# **Awel y Môr Offshore Wind Farm**

## **Applicant's Response to the Examining Authority's Third Written Questions**

### **Deadline 7**

**Date: 08 March 2023**

SCALE: 1:10,000    PLOT SIZE: A3    DATUM: ODN    COORDINATE SYSTEM: British National Grid

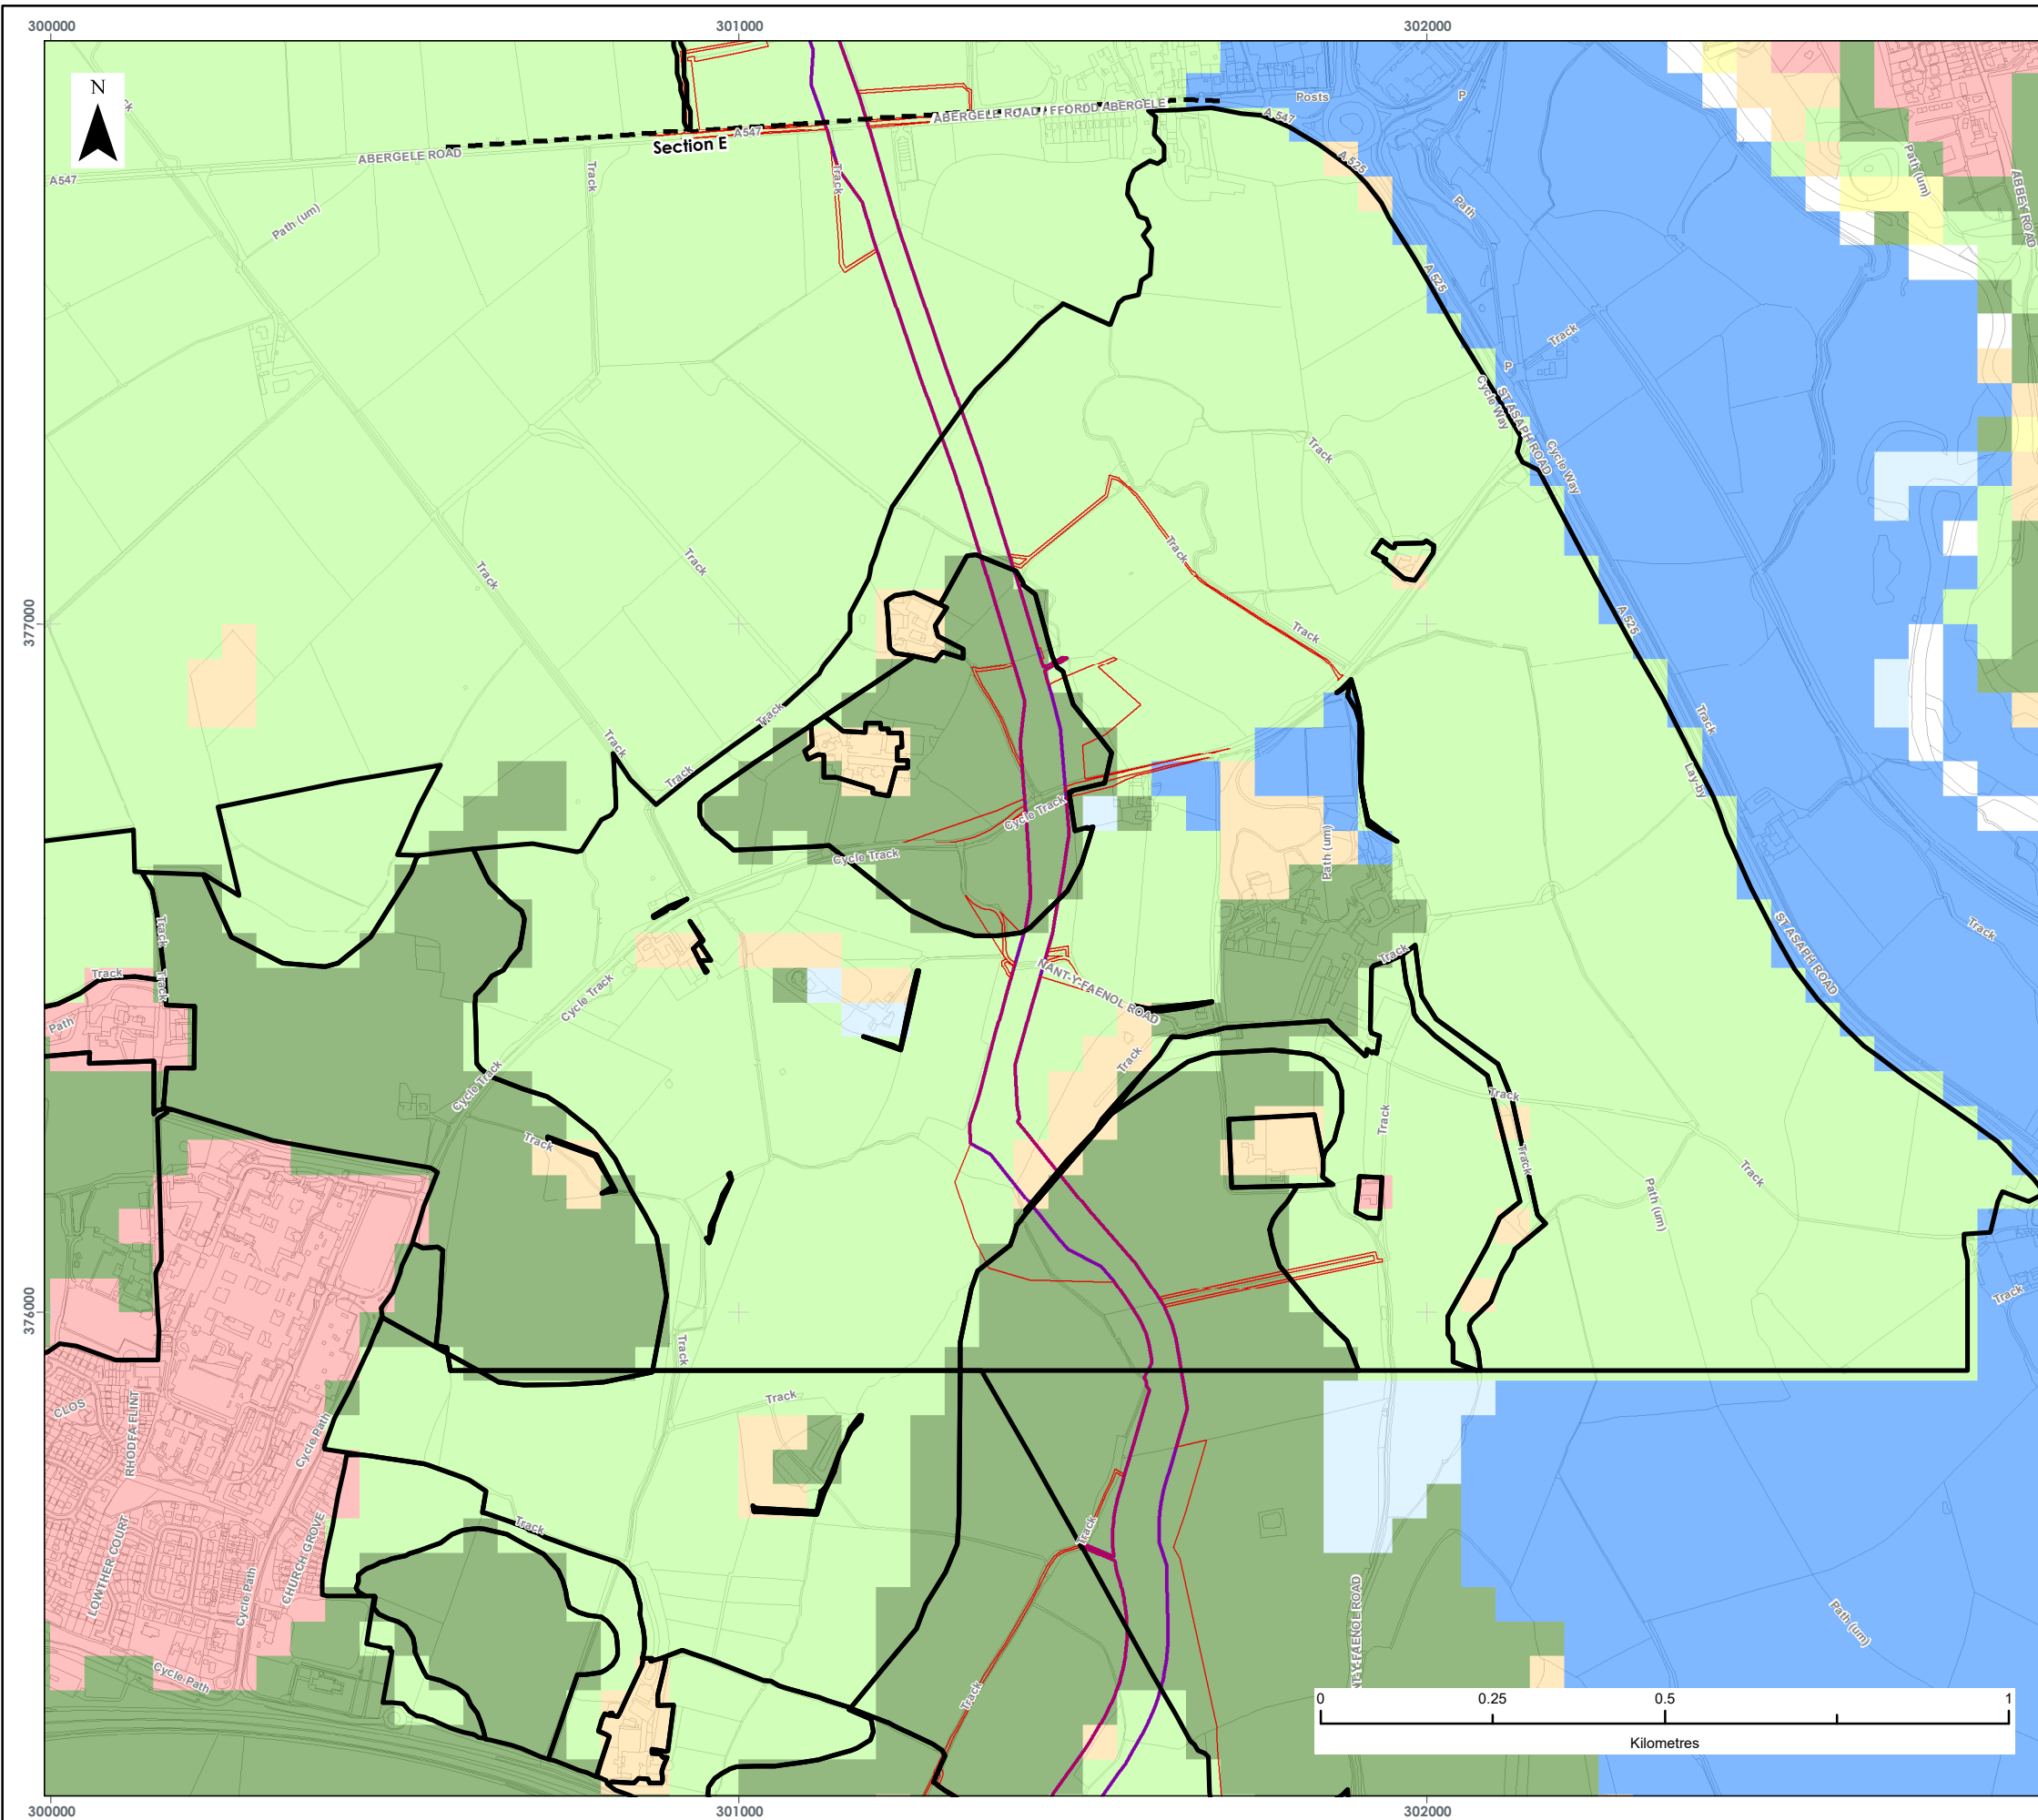
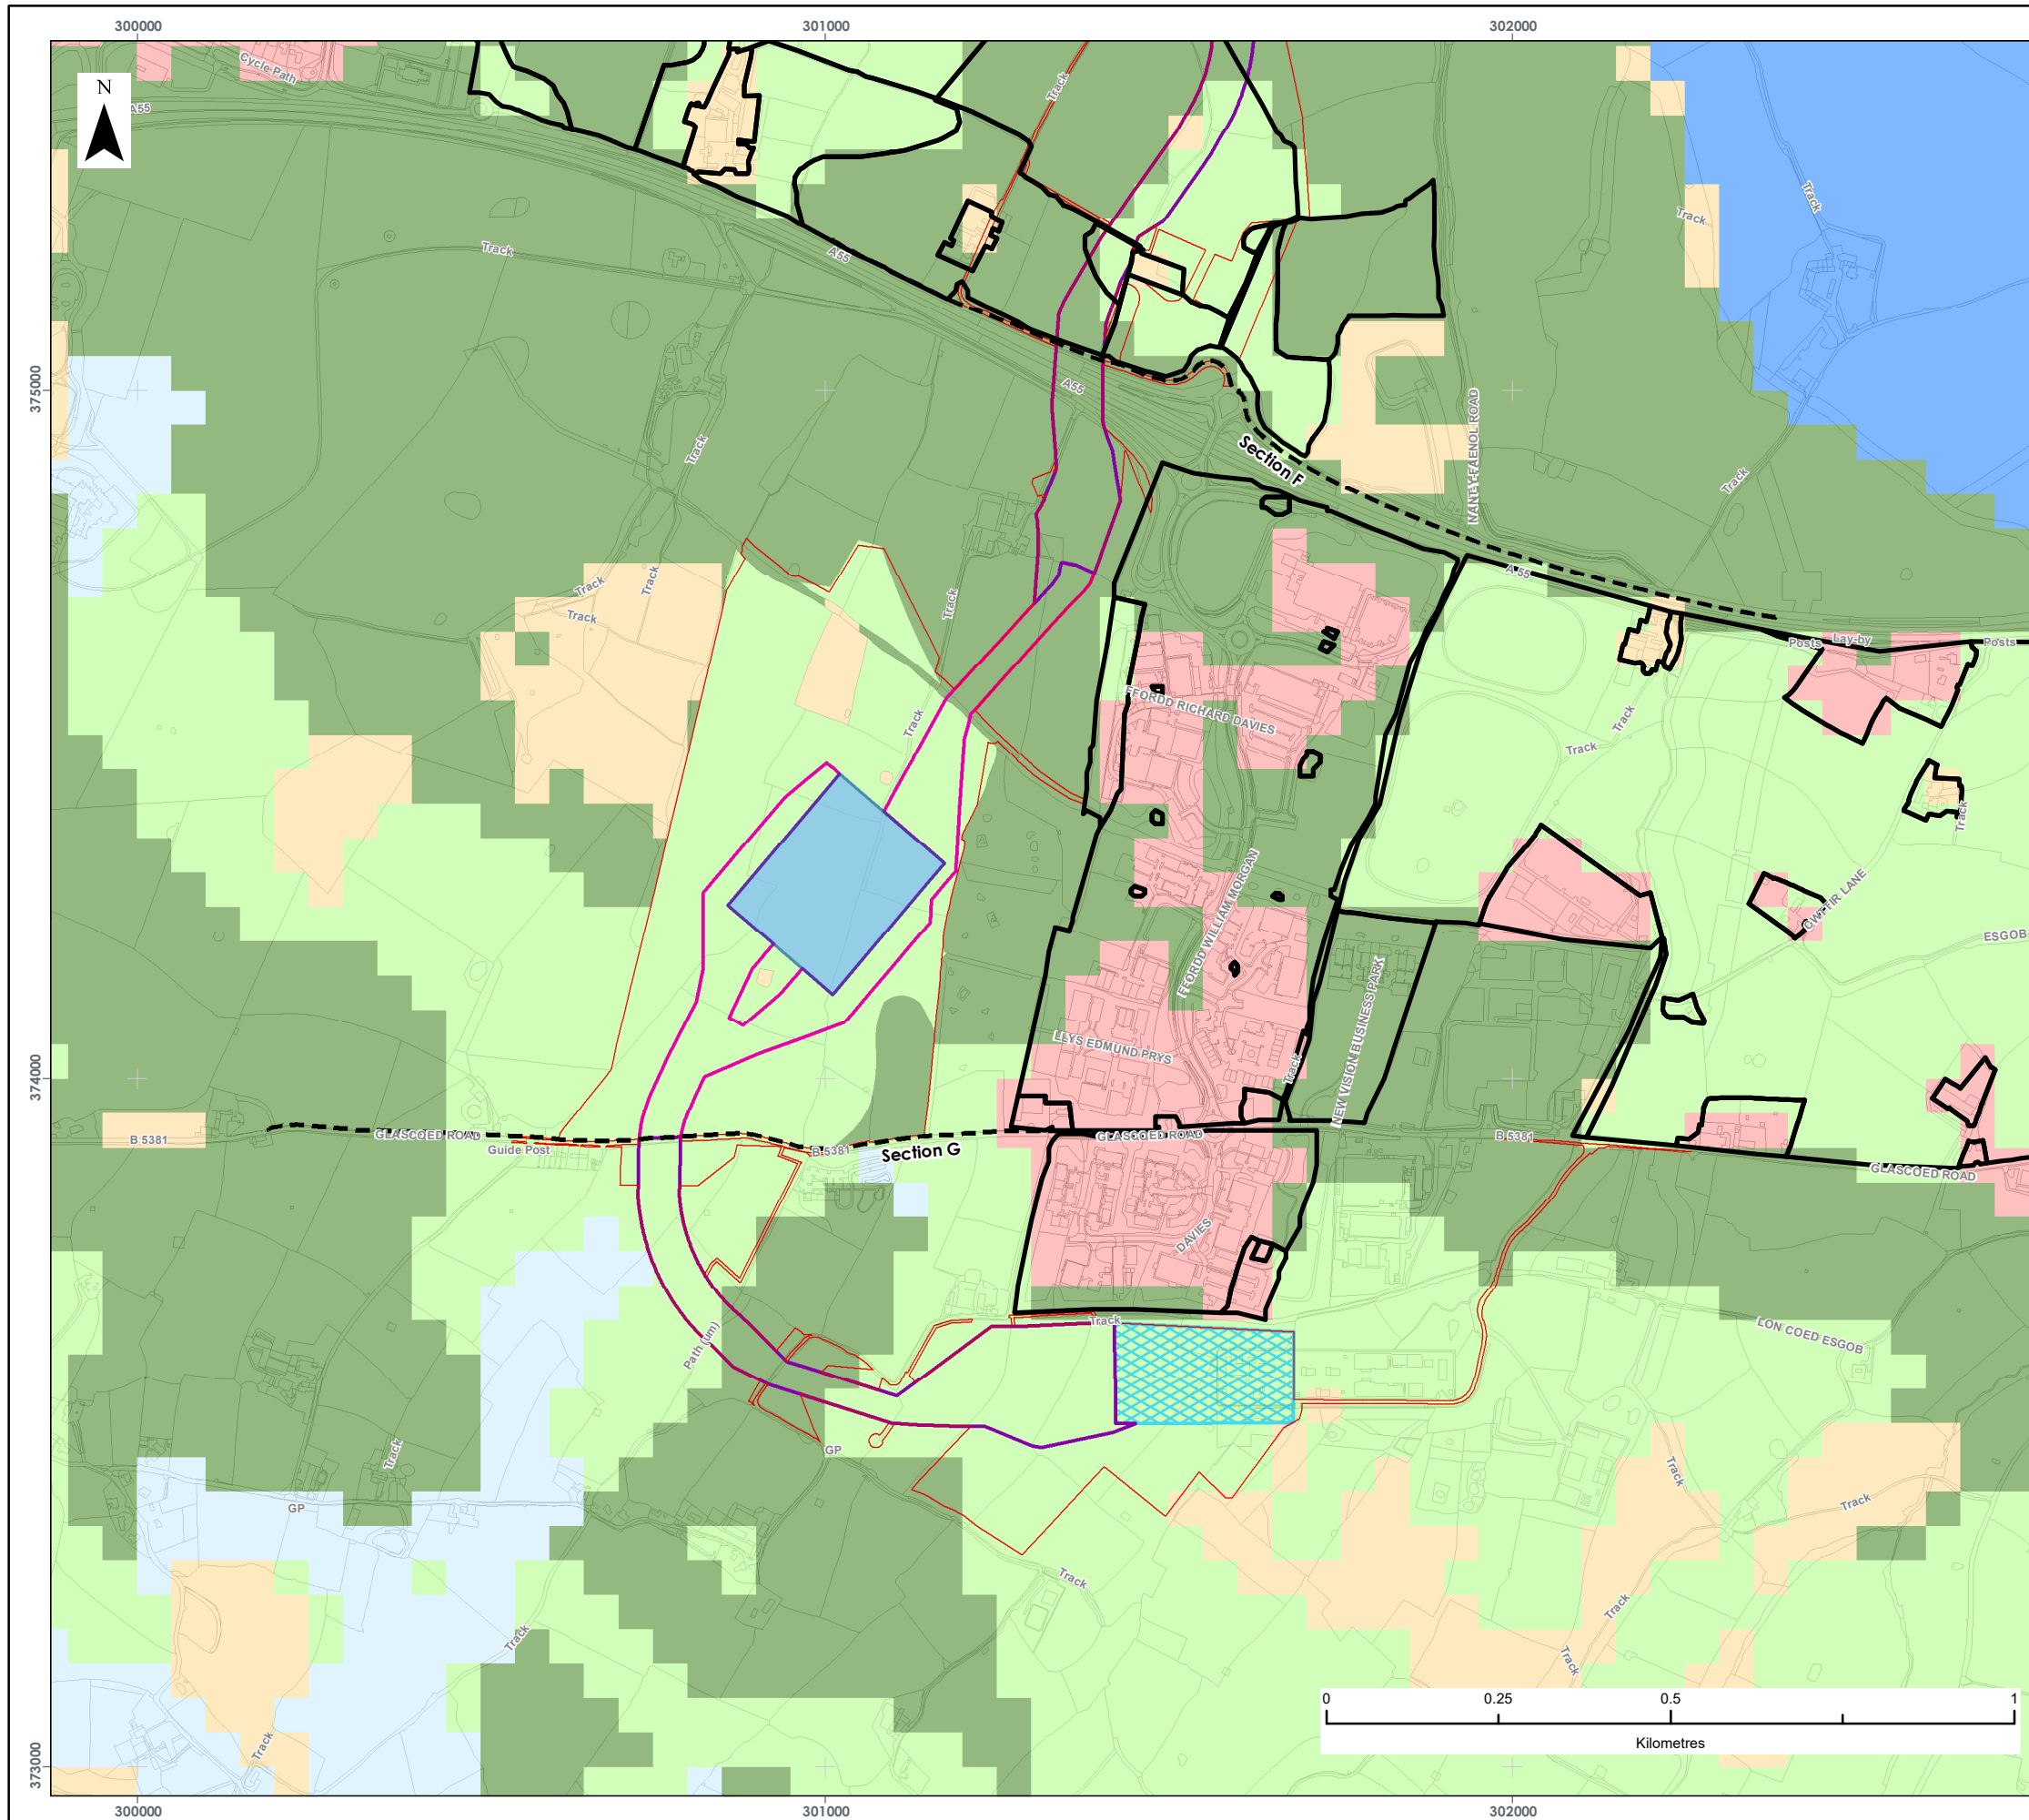
QUESTION NUMBER	QUESTION ADDRESSED TO	QUESTION	APPLICANT'S RESPONSE																											
	Farming Company																													
9.6	Applicant	<p><b>Onshore Substation Site (OnSS)</b></p> <p>Noting that a further Agricultural Land Classification (ALC) survey has been undertaken at the proposed OnSS site, is it necessary to update the table provided in response to ExQ1.9.8 [REP1- 007]?</p>	<p>The Applicant has updated the table to incorporate the results of the 2023 Agricultural Land Classification (ALC) survey as follows:</p> <p>The area of the OnSS footprint and wider landscape mitigation and ecological compensation and enhancement area (Plot 417), includes 1.5 Ha of Grade 3a which represents 0.69% of Grade 3a within 1000m of OnSS and 0.011% of Grade 3a land in Denbighshire.</p>
